Work Order ID 96688

Item Name: Crosstube Fwd

DRAWING NO. D206-667-143	TITLE CROSSTUBE ASS'Y (206L HIGH FWD)	REV. C	DART AEROSPACE LTD ENGINEERING ORDER		D.E.O. NO. D206-667-143-C-1	SHEET NO. SHEET 1 OF 1	SCALE NTS
DRAWN 97	CHECKED ASS	MFG. APPR. [Signature]	APPROVED MD		DE APPR. [Signature]		
DATE 11.07.15	DATE 11.07.20	DATE 11.07.21	DATE 11/07/21		DATE 11.07.21

DRAWING NO. D206-667-143	TITLE CROSSTUBE ASS'Y (206L HIGH FWD)	REV. C	DART AEROSPACE LTD ENGINEERING ORDER		D.E.O. NO. D206-667-143-C-2	SHEET NO. SHEET 1 OF 1	SCALE NTS
DRAWN AJS	CHECKED	MFG. APPR. <i>E</i>	APPROVED <i>AP</i>	DE APPR. <i>TH</i>			
DATE 12.08.02	DATE 12.08.02	DATE 12.08.02	DATE 12.08.02	DATE 12-08-02

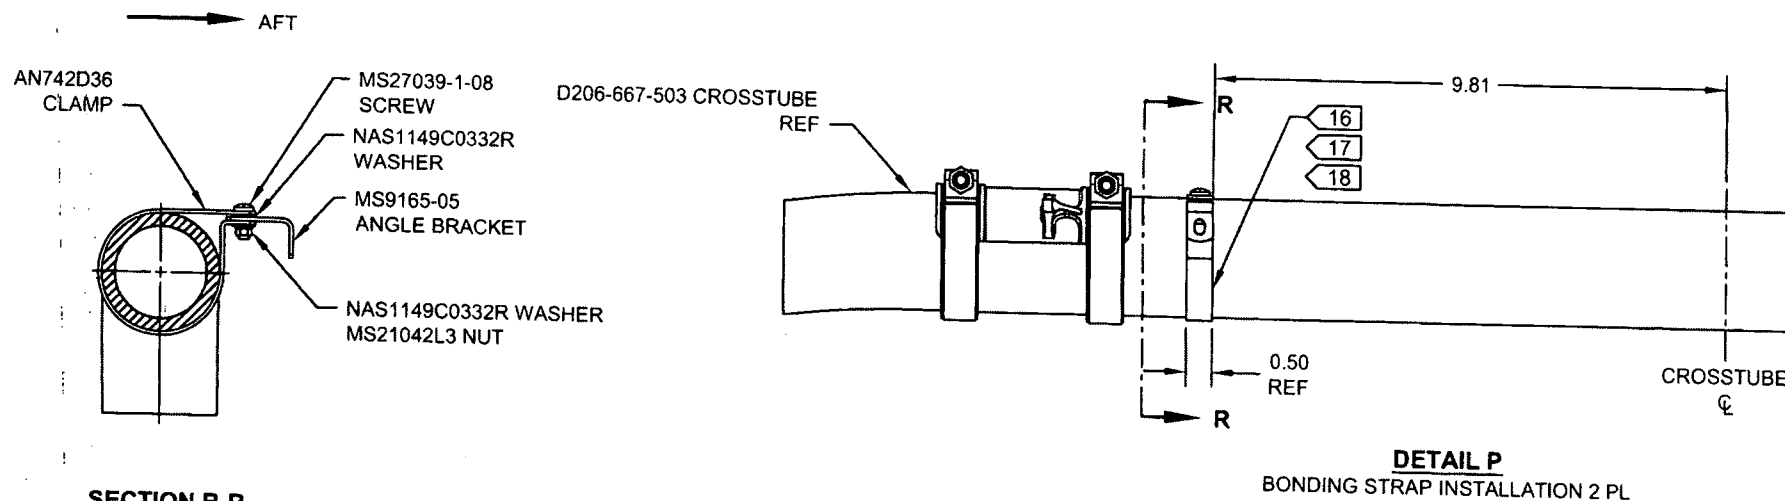
ADD ELECTRICAL GROUNDING STRAP

ITEM	QTY -143	PART NUMBER	DESCRIPTION
1	X	D206-667-143	CROSSTUBE ASSEMBLY (206L HIGH FWD)

10	2	AN742D36	CLAMP
11	2	MS9165-05	ANGLE BRACKET
12	2	MS21042L3	NUT (OR MS21042-3)
13	2	MS27039-1-08	SCREW
14	4	NAS1149C0332R	WASHER (OR AN960C10L)

DETAIL P
BONDING STRAP INSTALLATION 2 PL
